MEMORANDUM

To: The Design Advisory Board
From: Ken Lerner 
RE: ZP 12-0053CA/CU 371 Maple Street
Date: August 9, 2011

File: 12-0053CA/CU
Location: 371 Maple Street
Zone: I Champlain College Core Campus (ICC-CC) overlay **Ward:** 6
Date application accepted: July 15, 2011
Staff site visit: November 2, 2010.
Applicant/ Owner: Colin Lindberg Architects / Champlain College
Request: Addition to Hauke Hall; approx. 38,320 sf new construction providing classrooms, transit lounge, coffee shop, bike storage & offices

Figure 3: Pedestrian circulation from and through the site

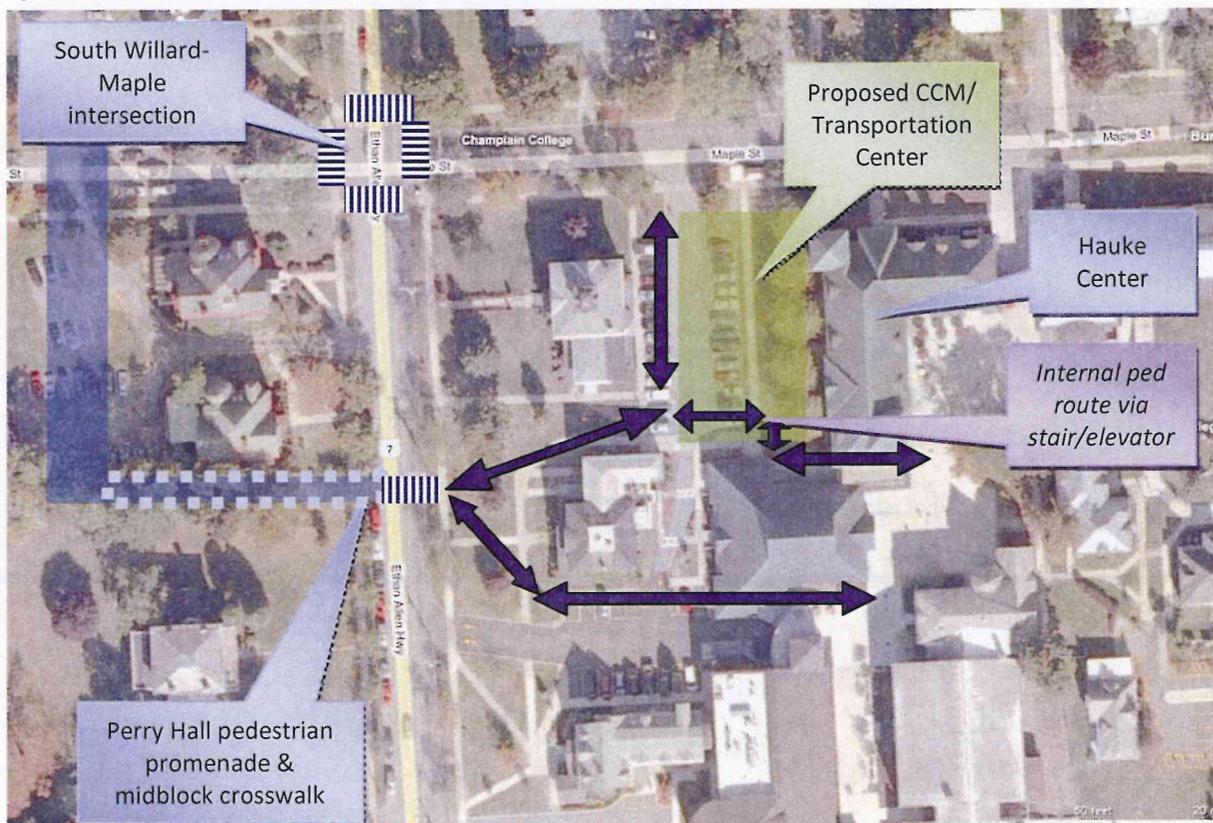
As shown in Figure 3, pedestrian flow through the CCM will be provided east-west through an internal stairway and elevator on the south end of the building, in the vicinity of the existing external east-west

North-south circulation will continue to be outside, along approximately the same alignment as is currently used by pedestrians through the parking lot. This north-south alignment is proposed to resemble the north-south promenade at Perry Hall in terms of materials and pedestrian friendliness, and will serve as emergency/delivery vehicle access. In order to reinforce the pedestrian environment, the promenade will be 12' wide to deter unauthorized vehicles. Removable bollards will also be placed at the end of the promenade. The 12' width is narrower than the promenade at Perry Hall in order to preserve the pedestrian orientation. Placing a bus bay on Maple Street at the end of the promenade will communicate that vehicles are to remain outside of the site. This design will be an improvement over the current state in which pedestrians walk through the parking lot.

Figure 4: Delivery and emergency vehicle access

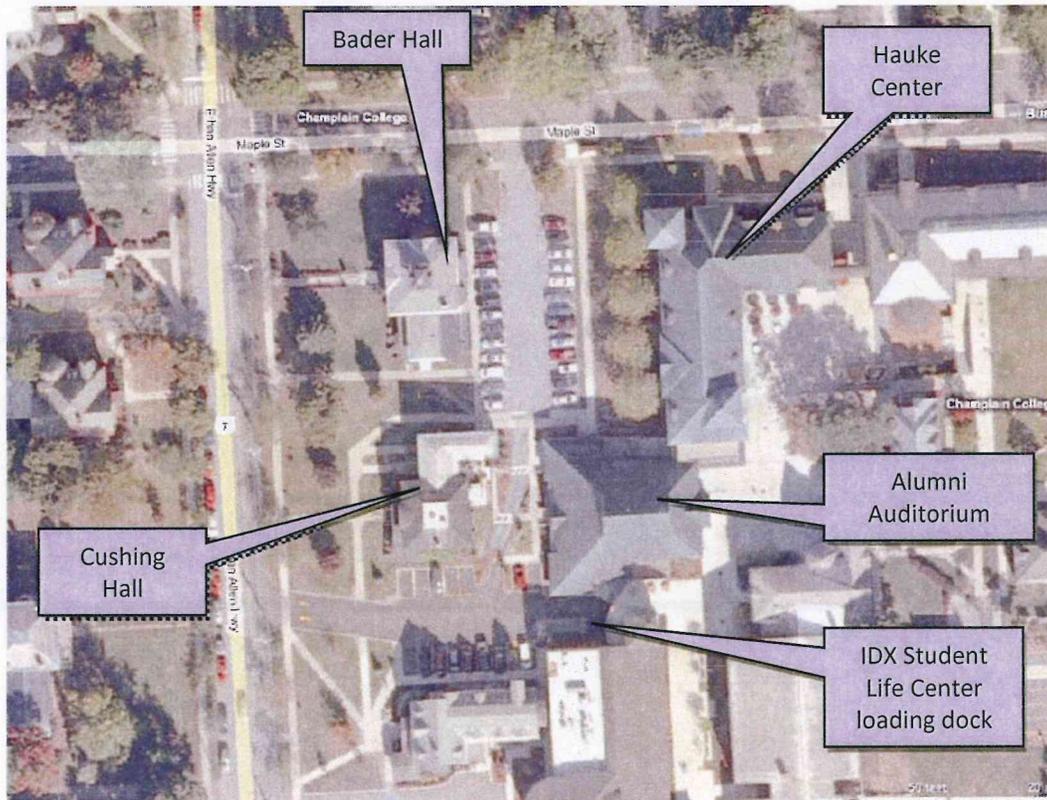
Large trucks (~43' trailers/50' wheelbase) make weekly deliveries to the IDX Student Life Center and will continue to maneuver as they do currently through the existing parking lot/proposed promenade as shown in Figure 4. Deliveries will be coordinated to occur during times of low pedestrian traffic.
